United States Patent and Trademark Office

APPLICATION N	O.	FILING DATE	FIRST NAMED INVENTOR	ATTORNEY DOCKET NO.	CONFIRMATION NO.
10/600,479		06/19/2003	Seiya Asano	3702/0M969US0	6321
7278	7590	06/30/2005		EXAM	INER
DARBY		BY P.C.	NGUYEN, XUAN LAN T		
	P. O. BOX 5257 NEW YORK, NY 10150-5257			ART UNIT	PAPER NUMBER
	,			3683	
				DATE MAILED: 06/30/200	5

DETAILED ACTION

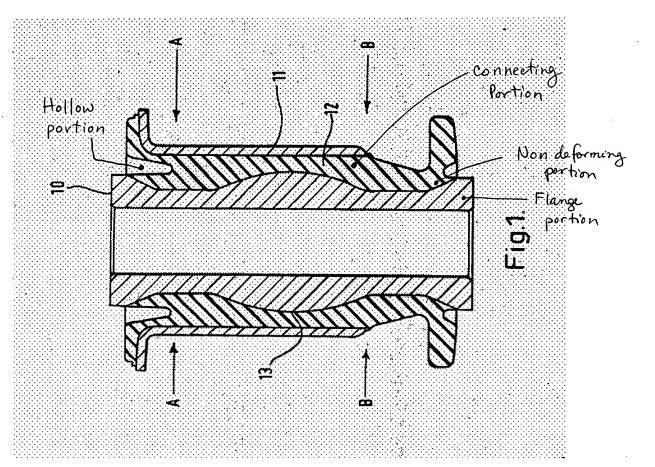
Re: claim 1, Nicholson shows a vibration isolating bushing in figure 1, as in the present invention, comprising: a main shaft member 10 including a tubular portion, a flange portion, as marked below, extending radially outwardly from one end of the tubular portion, and a block portion 13 provided on a central portion of the tubular portion and distanced from the flange portion in an axial direction of the main shaft member; an outer cylinder member 11 disposed coaxially on an outer side of the main shaft member in a distance therefrom; and a rubber elastic body 12 disposed between the main shaft member and the outer cylinder member integral connection of the main shaft member and the outer cylinder member, said rubber elastic body including a hollow portion, as marked below, which is open in an end face away from the flange

portion and extends in the axial direction; wherein the rubber elastic body further includes non-deforming rubber portion, please see the figure below, and a connecting portion, see the figure below; the non-deforming rubber portion fills a gap between the flange portion and an end face of the block portion facing the flange portion in the axial direction and is substantially undeformable with respect to an application of an axial load; the connecting portion is positioned between a bottom the hollow portion and the end face of the rubber elastic body on the side of the flange portion, for connecting the non-deforming rubber portion and an inner peripheral surface of an end portion of the outer cylinder member. Nicholson is silent of the cross-sectional shape of the hollow portion as claimed. Noboru et al. teach a vibration isolation bushing, especially a crosssectional shape of a hollow portion, in figures 2 and 4. In figure 4, the hollow portion 74 extends to a vicinity of an end face of a block portion 78. In figure 2, the hollow portion 74 directly surrounds the block portion extending circumferentially and over a side surface to the main shaft member 56. It would have been obvious to one of ordinary skill in the art at the time the invention was made to have modified Nicholson's bushing with a hollow portion such as taught by Noboru et al. in order to provide a softer ride since it is well known in the art of dampening to change the spring constant of the elastomer member in order to achieve a desired dampening results as evidenced by Norobu et al.

Re: claim 2, Nicholson shows the radial outer peripheral surface of the block portion 13 to be located more inwardly than an outer peripheral end of the flange portion.

Re: claim 3, Nicholson further shows the connecting portion to be offset inwardly compared to the non-deforming portion.
